STAFF REPORT

Case #28-17: **SITE PLAN REVIEW**

Case #29-17: **SPECIAL PERMIT**

801 Mt. Pleasant Street

Landscape / Lighting Plan (Sheet 4 of 7)

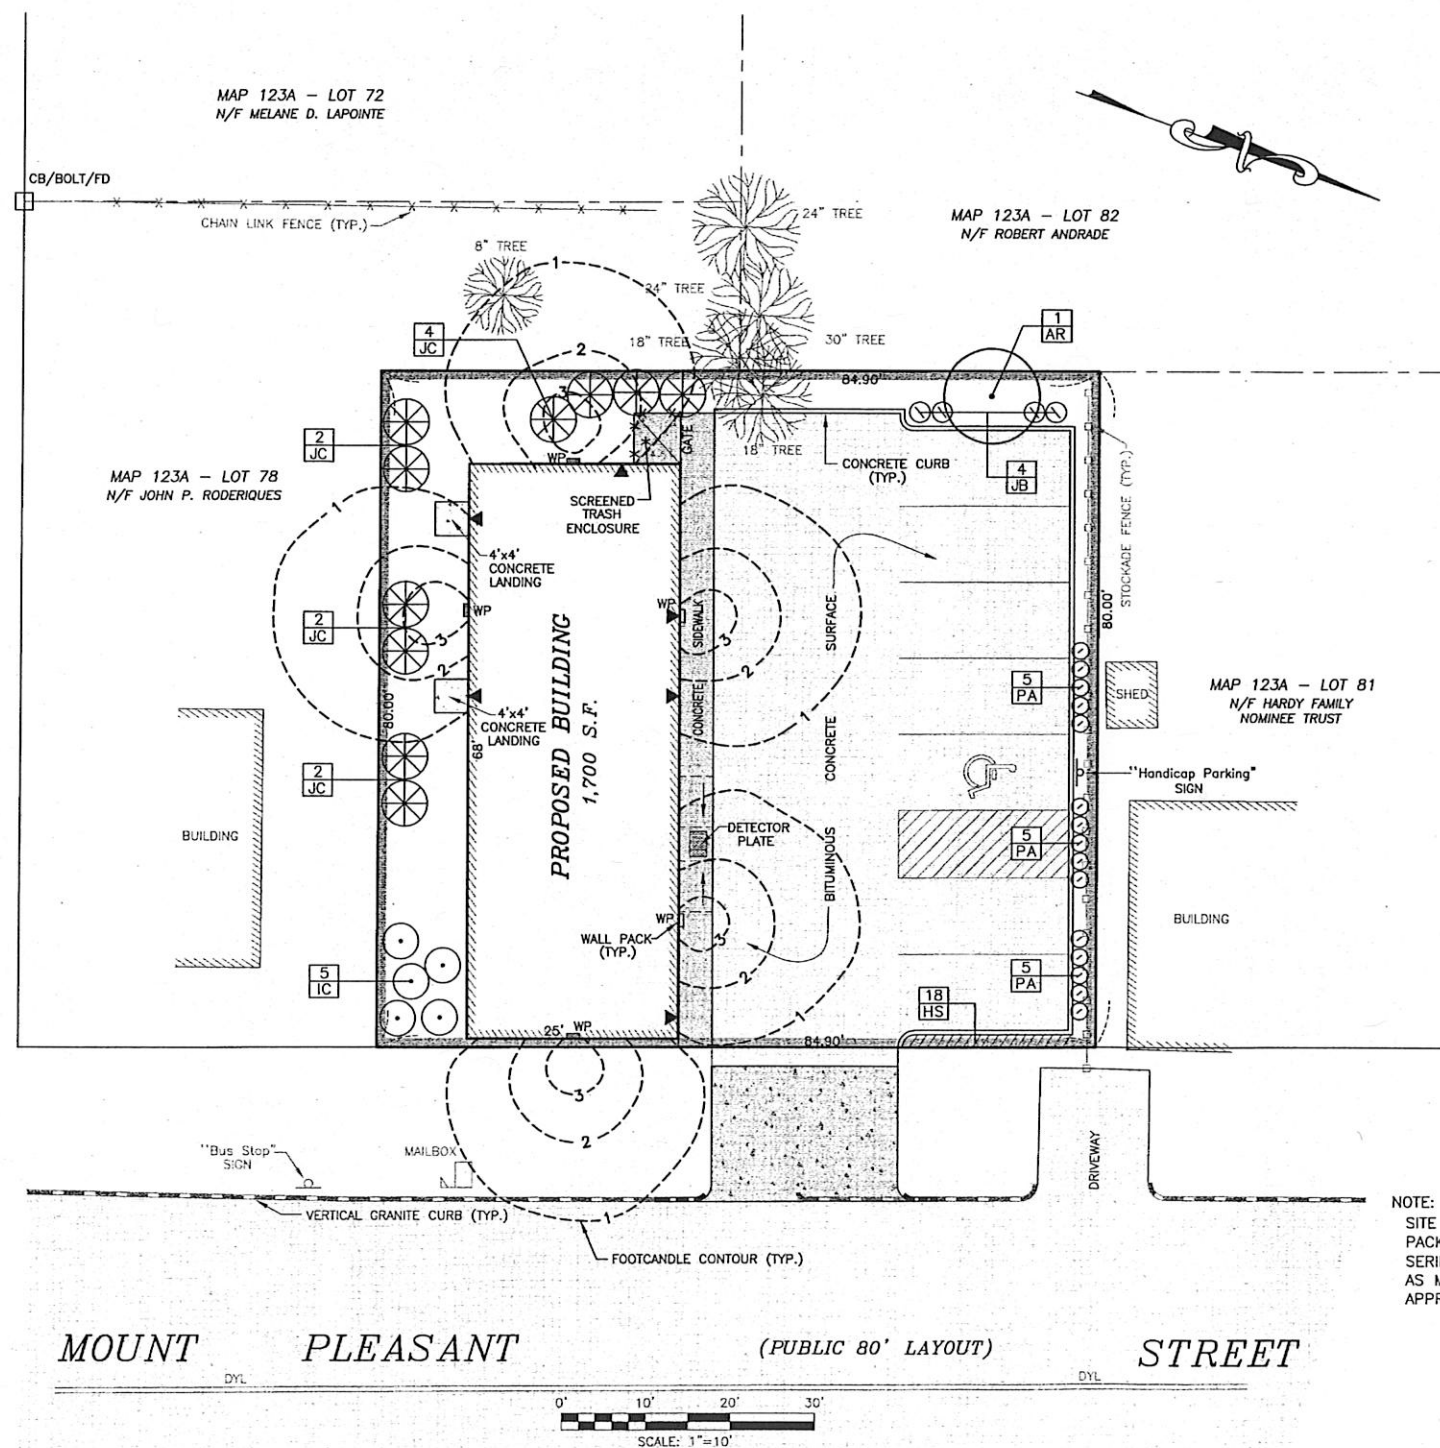
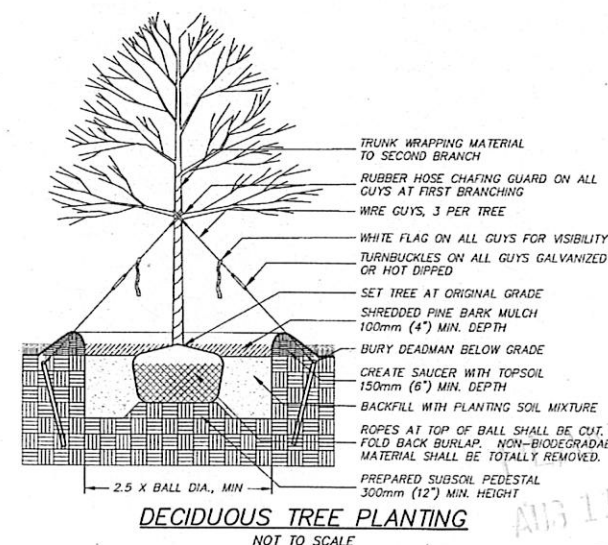
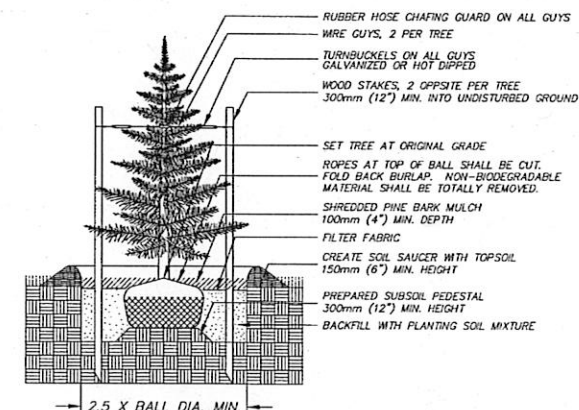
- ☐ Height of stockade fence shall be noted on plan. Height shall be at least six (6) feet but no greater than ten (10) feet as per **§3333**.
- ☐ Additional trees and shrubs shall be added along stockade fence line as per **§3332**.
- ☐ Revise Note on planting schedule to reflect tree diameter of *October Glory Red Maple* to be a minimum of 3" at a point, six (6) inches from ground level.
- ☐ Note snow storage area(s)
- ☐ Verify site distances at entrances.

Existing Conditions (Sheet 6 of 7)

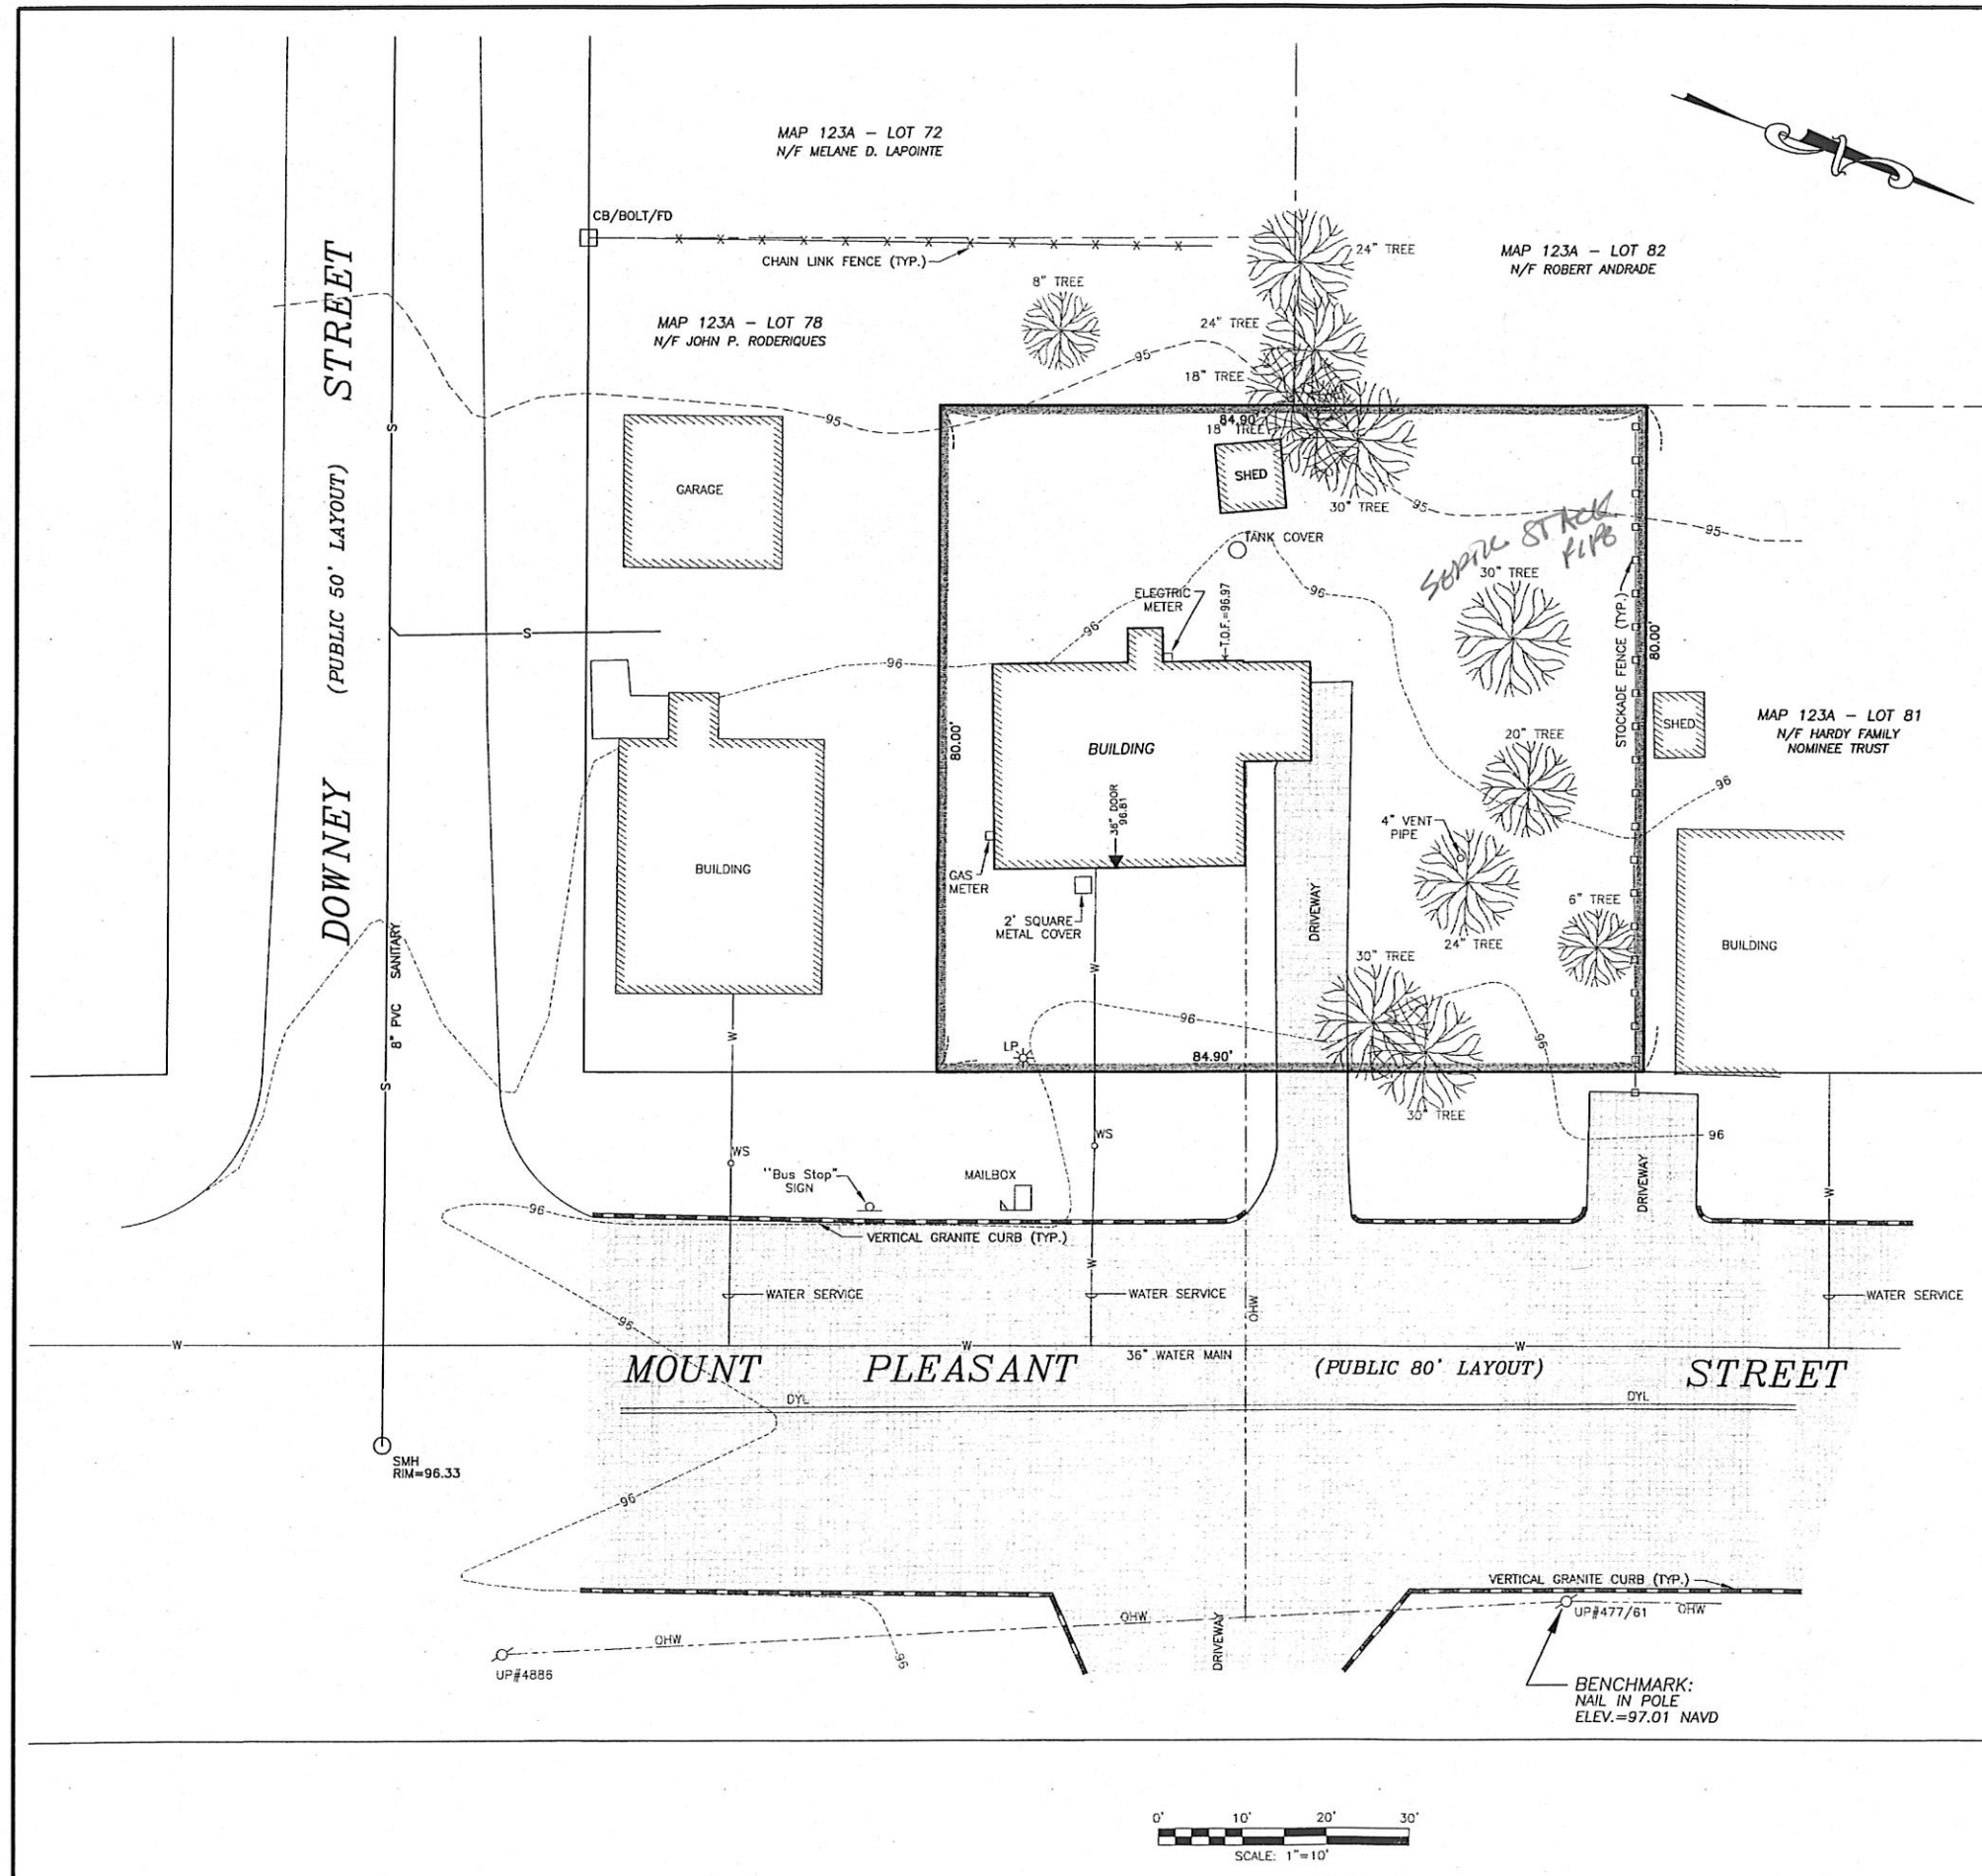
- ☐ Staff site visit finds evidence of a septic system. The applicant should provide evidence that septic service has been discontinued and system has been properly removed.

Proposed First Floor Plan

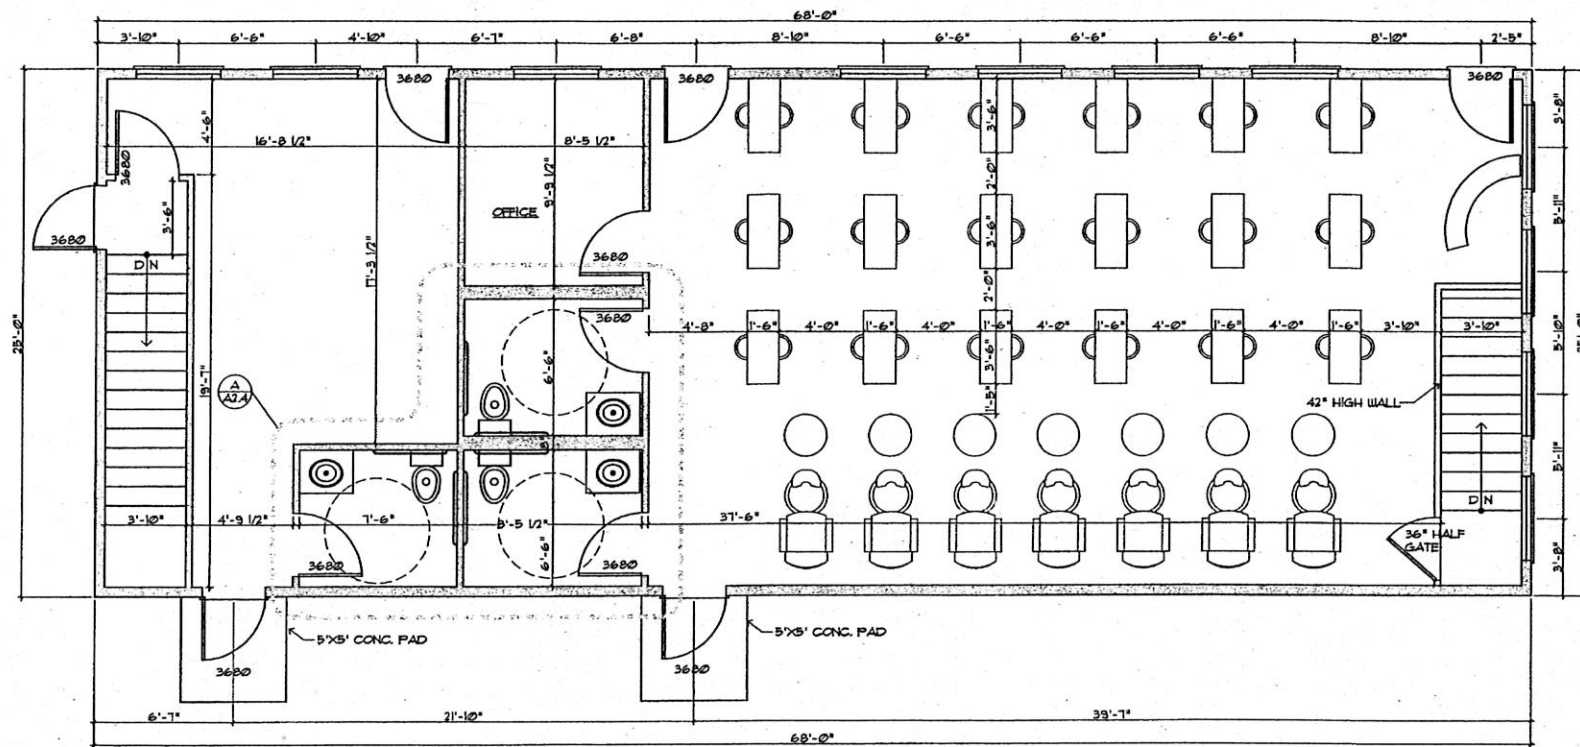
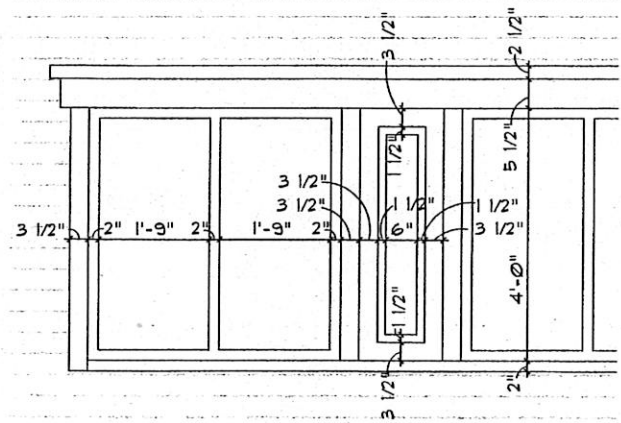
- ☐ Show lighting location on building elevation drawings.
- ☐ Identify/provide all existing and proposed exterior materials, treatments and colors-including roofing, roof eaves, eave brackets, siding, doors, trim, sills, windows, fences, and railings. Staff recommends that material specifications for the exterior expansion should be reviewed and approved by the Planning Board or City Planner before construction commences.
- ☐ Show/provide details of proposed new exterior elements.
- ☐ Show any exterior mechanical, duct work, and/or utility boxes.

A PROPOSED FRONT ELEVATION
SCALE: 1/4" = 1'-0"

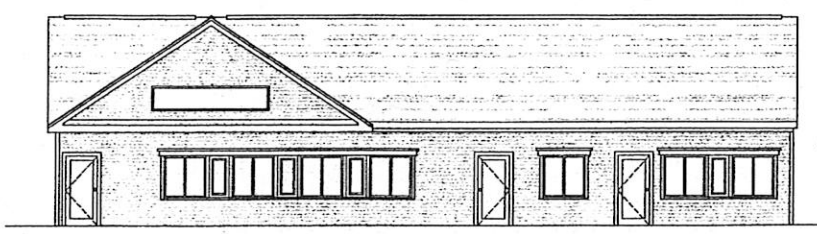
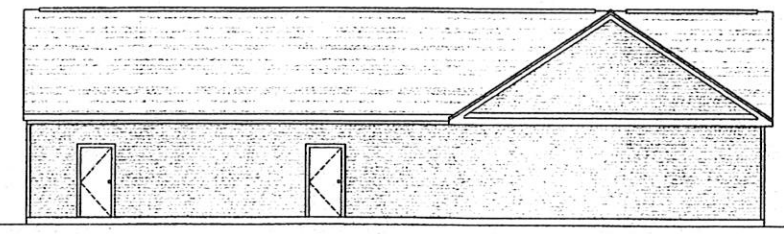
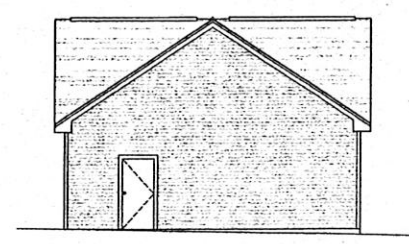
- ☐ Sign and Sign Schedule are omitted from elevation drawings. Staff recommends that applicant provide plans & specs for review and approval by Planning Board or City Planner.

- ☐ Show lighting location on building elevation drawings.
- ☐ Identify/provide all existing and proposed exterior materials, treatments and colors-including roofing, roof eaves, eave brackets, siding, doors, trim, sills, windows, fences, and railings. Staff recommends that material specifications for the exterior expansion should be reviewed and approved by the Planning Board or City Planner before construction commences.

- ☐ Applicant to show/provide details of proposed new exterior elements.
- ☐ Plans to show any exterior mechanical, duct work, and/or utility boxes.
- ☐ The applicant has not provided a DIS for the proposed development.
